UNITED STATES
ATOMIC ENERGY COMMISSION
WASHINGTON 25, D.C.

LR:JED REFER TO:
70-139

Will you please authorize transfer to our License SNM-185 under Lease Agreement 126, 5,087.2 grams of SS Net and 4,738.8 grams of U-235. The metal is in the form of scrap held on our premises under Nuclear Material Draft No. IDO-4000-130.

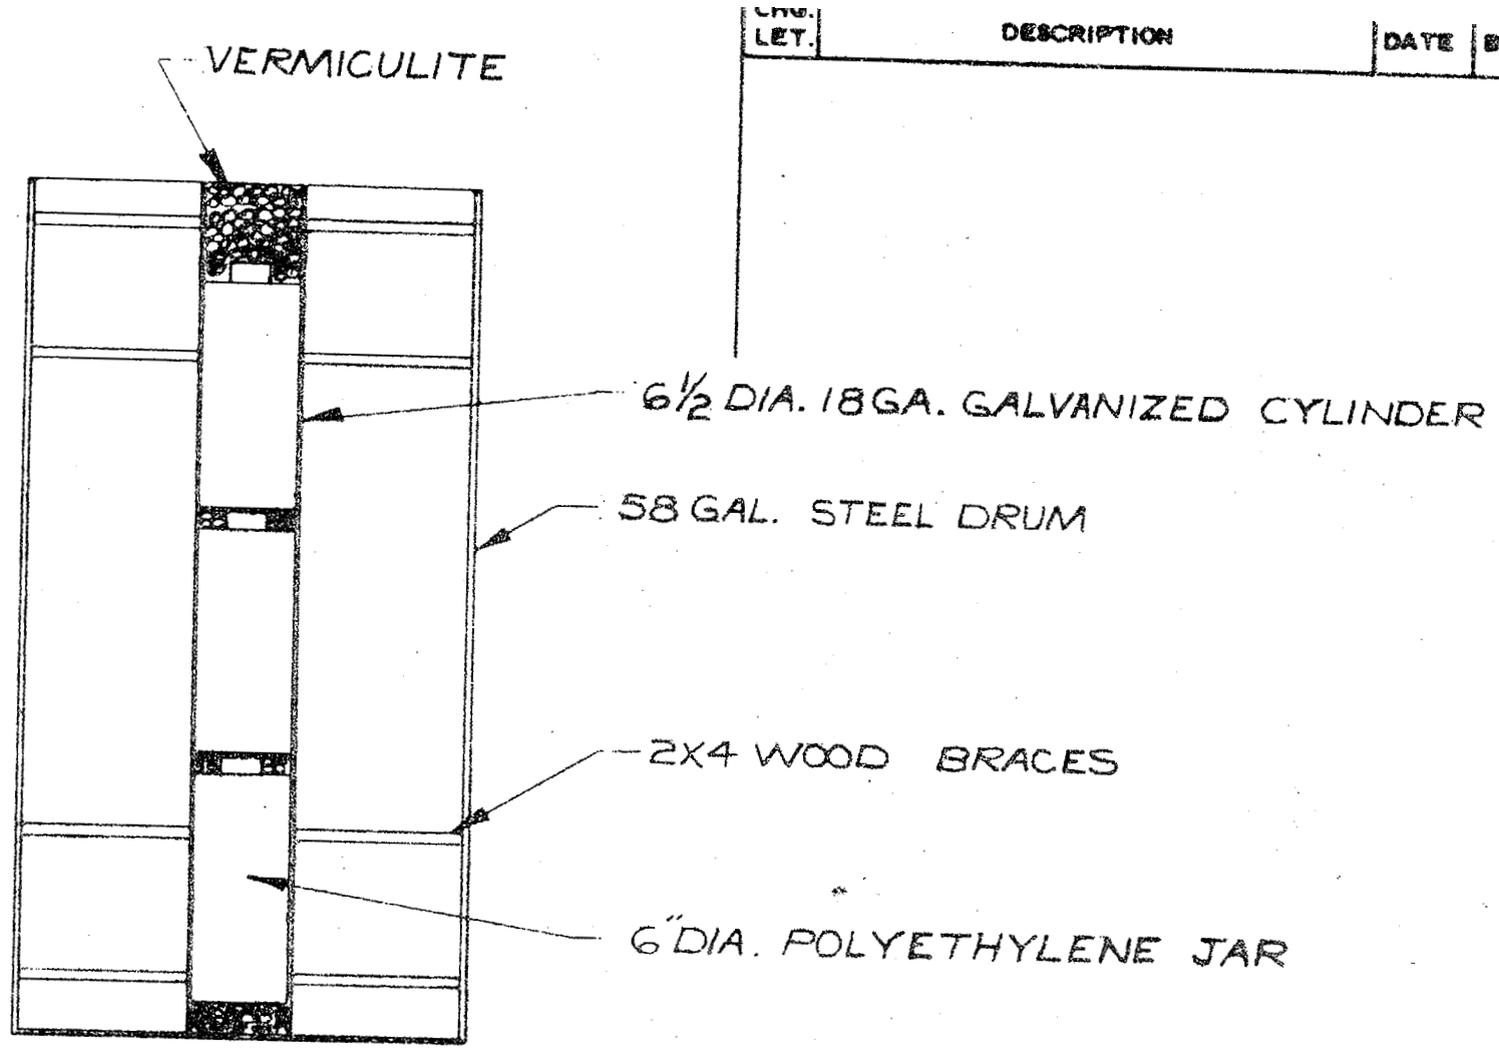
It is our opinion that the 18 gage inner container that you have proposed is not structurally substantial enough for shipments of this type. It is believed that the inner container should be equivalent to Schedule 40 stainless steel pipe, with welded bottom and flanged and gasketed top. An example of such a container is shown on page 47 of TID-7019, "Guide to Shipment of U-235 Enriched Uranium Materials". Therefore, it will be necessary for you to provide additional information to either justify the adequacy of your proposed container or to amend your request by the inclusion of a more structurally sound inner container before further action can be taken on your application.
